NUREG-0139

# **environmental statement**

## **CLINCH RIVER BREEDER REACTOR PLANT**

FEBRUARY 1977

FIGURE 2.6 Population Distributions for 1970 and 2010 within 5 Miles and 50 Miles of the Site

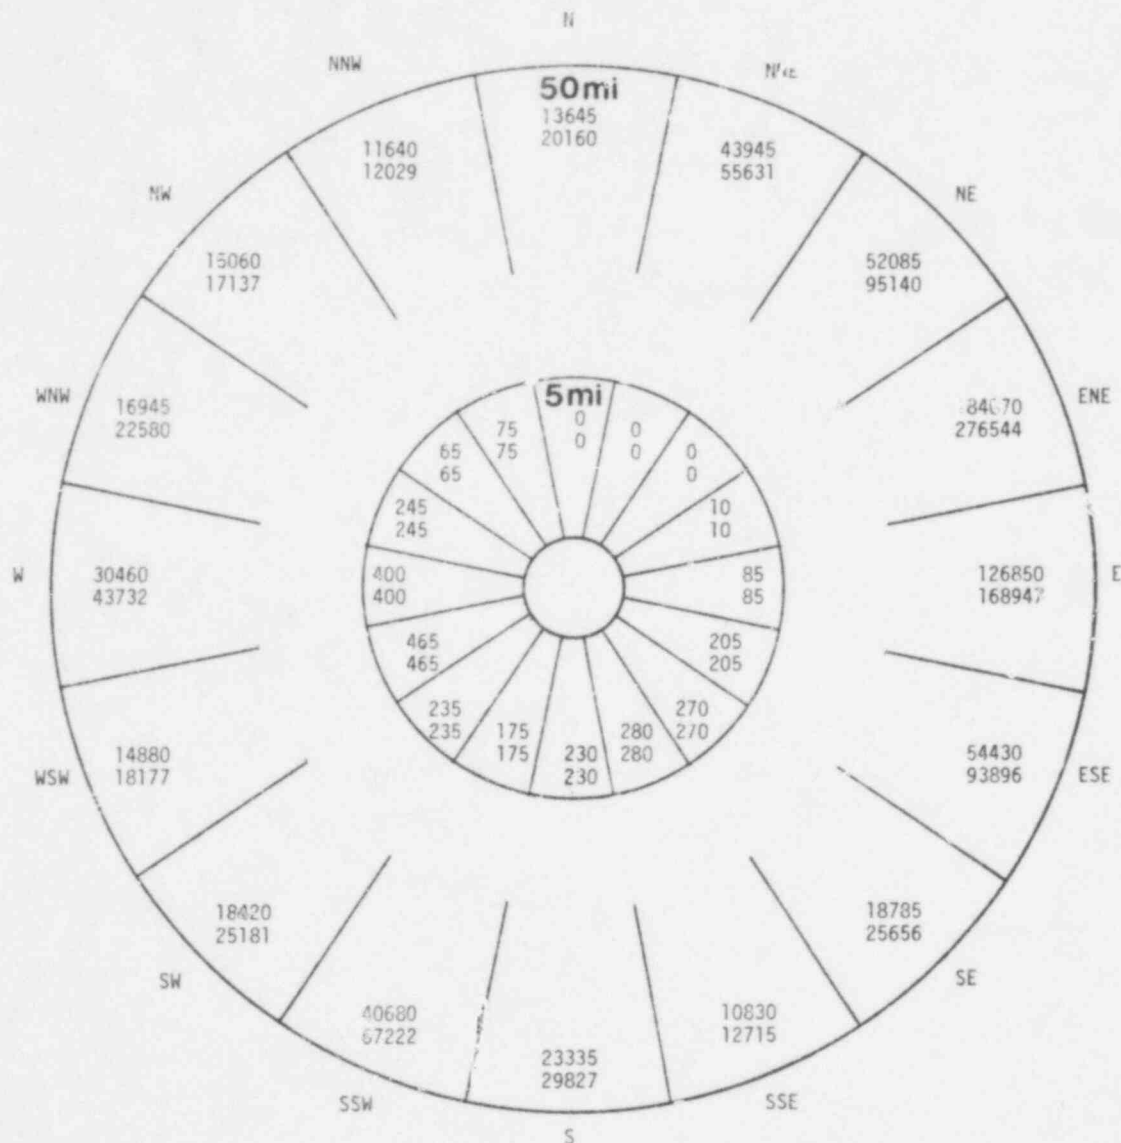
8. Include a political jurisdictional map, i. e., showing boundaries of the authority of planning commissions, fire districts, water districts, etc.
  9. Section 2.2 and Fig. 2.6 may be misleading. Growth within a five-mile radius was projected in the applicant's Environmental Report since it contains a large percentage of the potential locations for trailer parks for construction workers, whereas, the DES projects no growth within this five-mile radial area. Also, long-range growth of residential Oak Ridge includes areas within five miles of the site. Moreover, depending on what portion of the site one takes as the center of the circle of radius of five miles, there may be no residences to the north, but there are always people to the north at the ORGDP and the Clinch River Industrial Park. Any discussion of population concentrations should take into consideration day and night time variations related to community activities.

Section 2.2 is expanded to recognize the ORGDP, ORNL, and other workers within 5 miles, in addition to the references to them in Sections 2.1 and 2.8. The 2010 estimates shown in Figure 2.6 are taken from the ER. (Sec 2.2.1.1, par 5 and 7 including Tab 2.2-4 through 2.2-7.) The staff notes the possibility of temporary mobile home locations within 5 miles during construction, depending upon future decisions of the city government.

FIGURE 2.7 Archaeological and Historical Sites

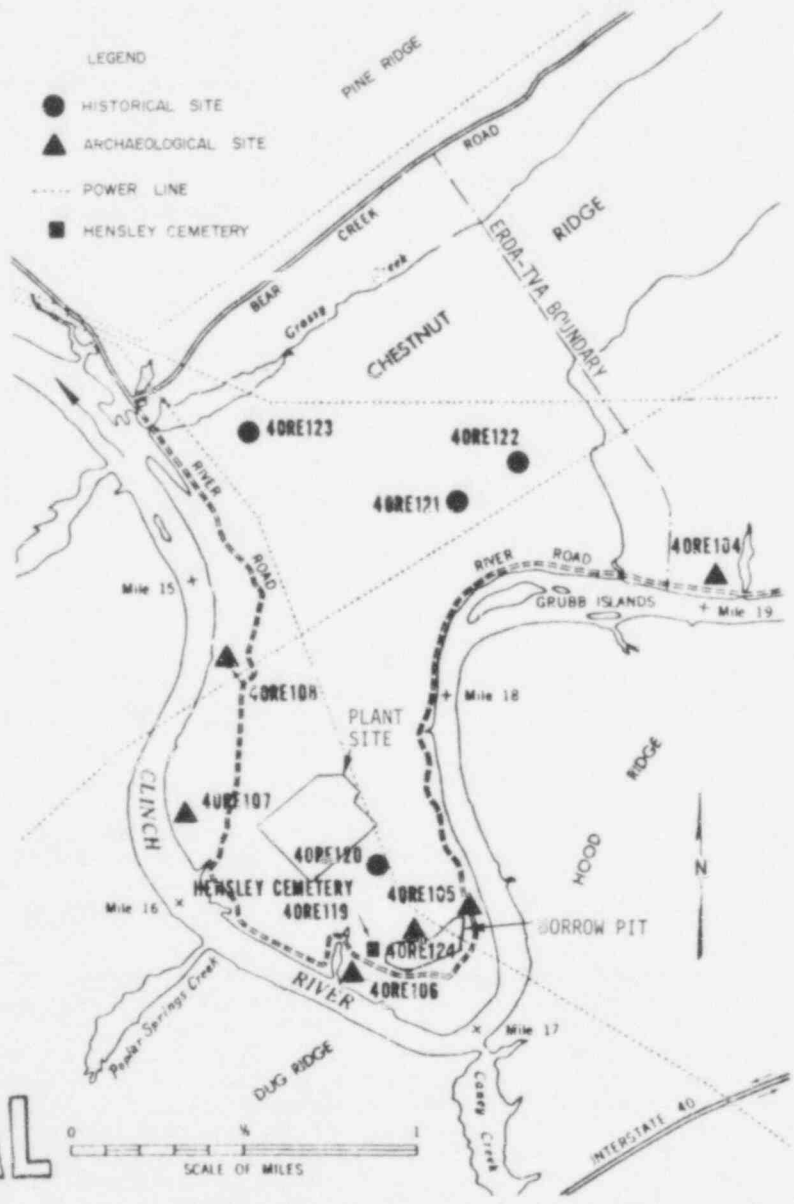
Figure 2.7 should indicate construction areas.

The Advisory Council on Historic Preservation states that historic and archaeological values receive adequate consideration in the DES (page A-2). The staff considers the discussion in Section 2.3 adequate in view of the anticipated impacts, which are judged to be small (Sections 4.2.1 and 5.1). Construction areas have been added to Figure 2.7. Refer also to Figures 2.3 and 3.3.

FIGURE 2.9 Annual Onsite Wind Roses (ER, Fig 2.6-4 and -9)

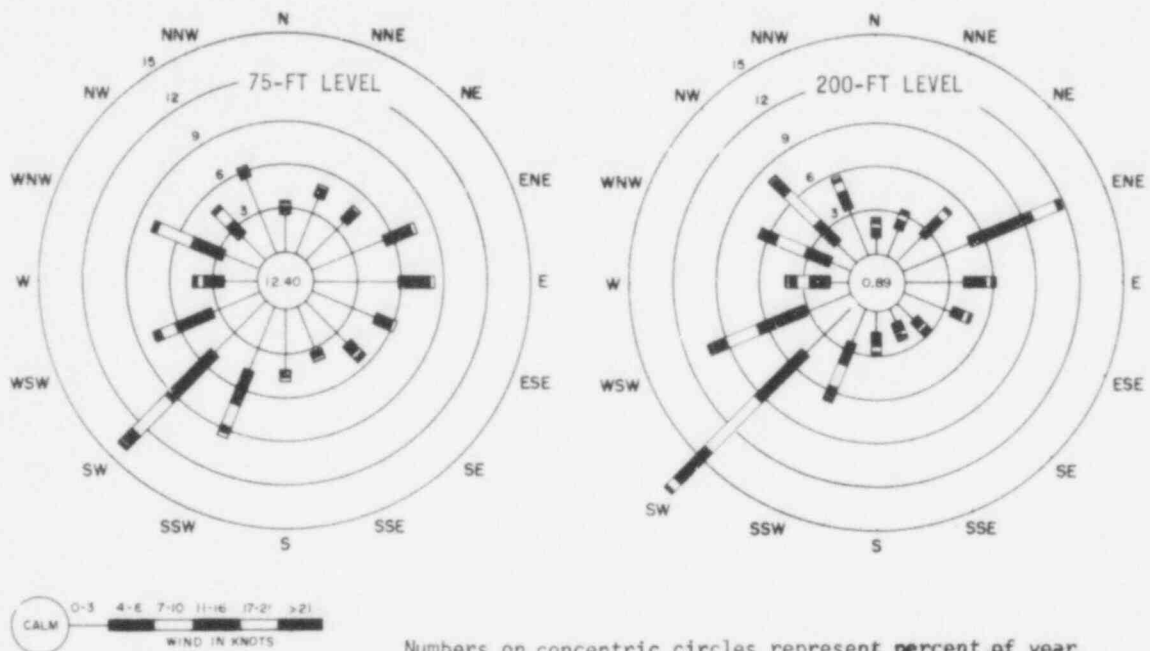
- 716  
309
13. Figure 2.9 should be labeled such that it is apparent whether the wind roses indicate the direction from which the wind is blowing or to which the wind blows.

FIGURE 3.8 Intake Pipe

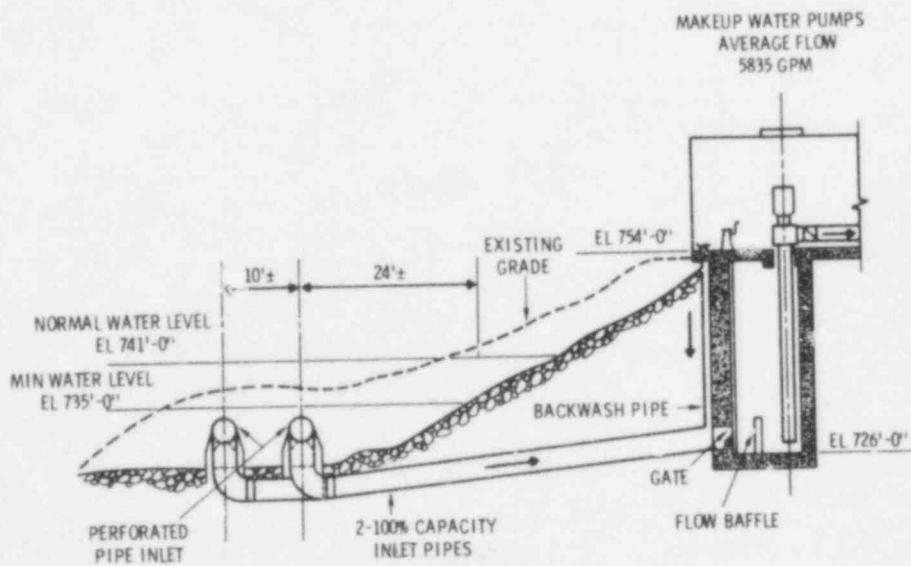
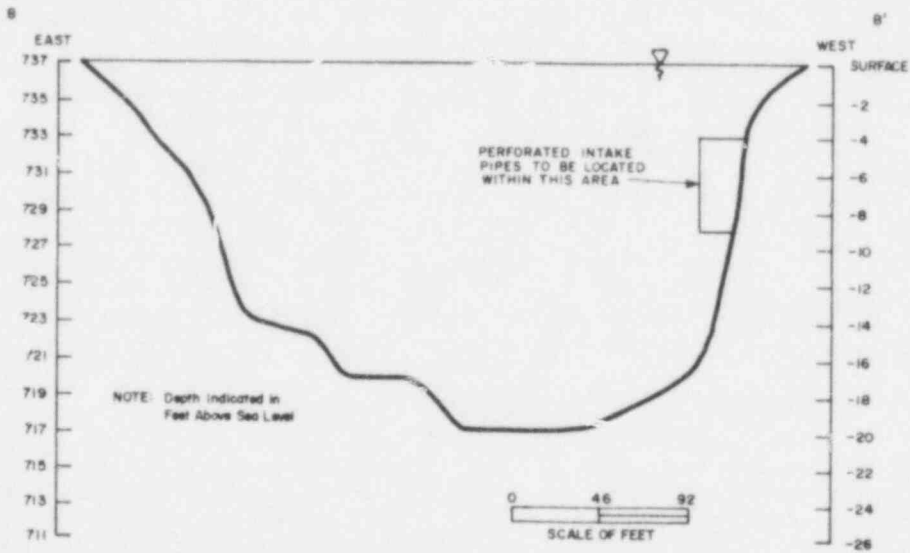
Figure 3.8 shows the tops of two intake pipes at approximately elevation 733 msl or higher. Figure 3.14 shows "intake pipes to be located within this area," the top of which is 724 msl. These figures should be checked for errors or discrepancies.

Figures 3.8, 3.12 and 3.14 have been revised in accordance with the Project's revised permit application to the Corps of Engineers (Caffey; July 8, 1976). Both the intake and discharge structures are recessed into the river bank to avoid obstructing navigation.

FIGURE 3.16 Gaseous Radioactive Waste Systems and CRBRP Ventilation

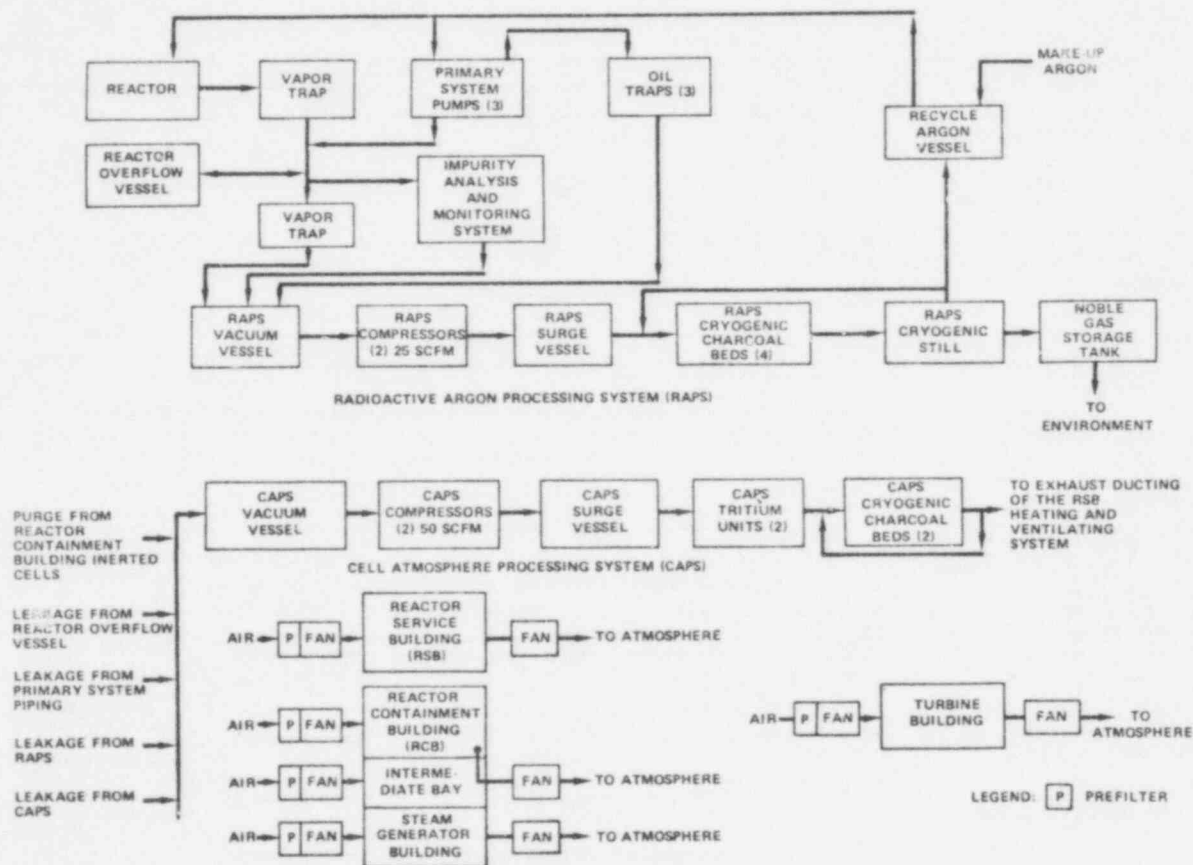
The schematic of the radioactive gase processing system in WASH-1509 (p.50), unlike the schematic in Figure 3.16 in the DRAFT (p.3-15), does not show a flow path from the noble gas storage tank to the environment.

FIGURE 6.2 Reservoir Monitoring Network for CRBRP (ER, Fig. 6.2-2)

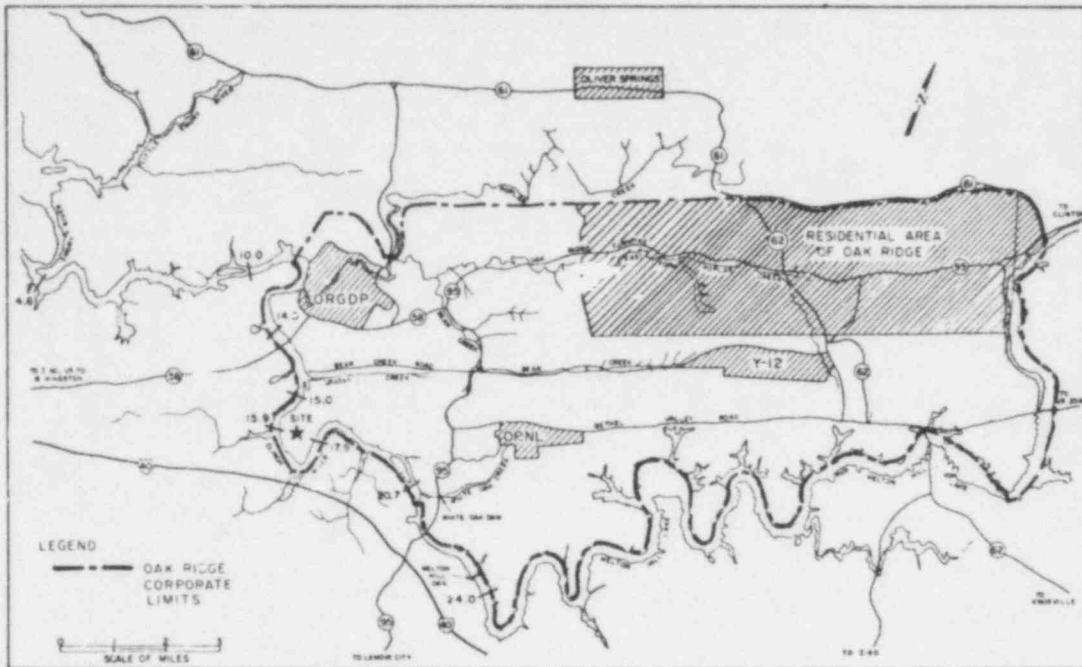
The pre-operational monitoring program at reservoir locations does not list these locations and the accompanying Figure 6.2 has no legend (pages 6-2, 6-3). In the later design of the operational radiological monitoring program (page 6-11), consideration should also be given to monitoring of storm drainage from buildings and yards, among other items.

The political jurisdiction of Oak Ridge is shown on Figure 6.2 as revised. Showing the boundaries of the service districts cited in the Oak Ridge comment is not essential to this statement. However, the staff's assessment of costs of municipal services resulting from the project is intended to include additional costs to the service jurisdictions.

Revised Table 6.1, along with Figures 6.1 and 6.2, should adequately identify the reservoir locations where samples will be taken. Consideration will be given to monitoring storm drainage from buildings and yards in design of the operational monitoring program.

Figure 1

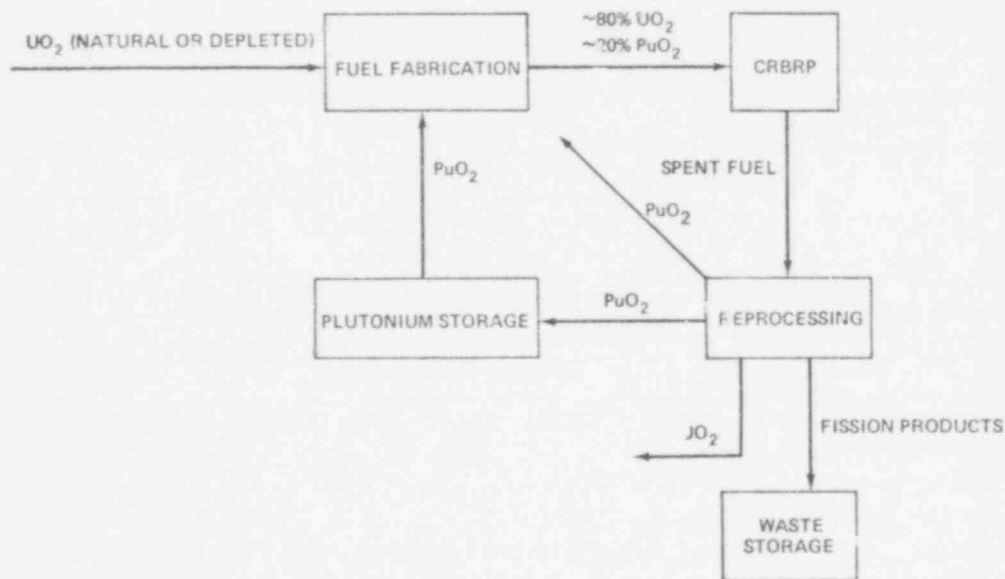
1. The text of Appendix D makes the point that depleted uranium, a byproduct of past enrichment processes carried out in this country, will be used as blanket and make-up fuel material for the CRSP core. However, Figure 1 of Appendix D, and Section 5.1 of Appendix E, indicate that natural uranium could be used in place of or in addition to depleted uranium. In our view, the reduction of uranium mining and milling impacts by utilizing existing stocks of depleted uranium, is an important benefit of the LWR. Such use also is in direct accord with NEPA's mandate to achieve the "...maximum attainable recycling of depletable resources." We hope the use of natural uranium, as opposed to depleted uranium stocks, will be minimized in the CRSP fuel cycle.
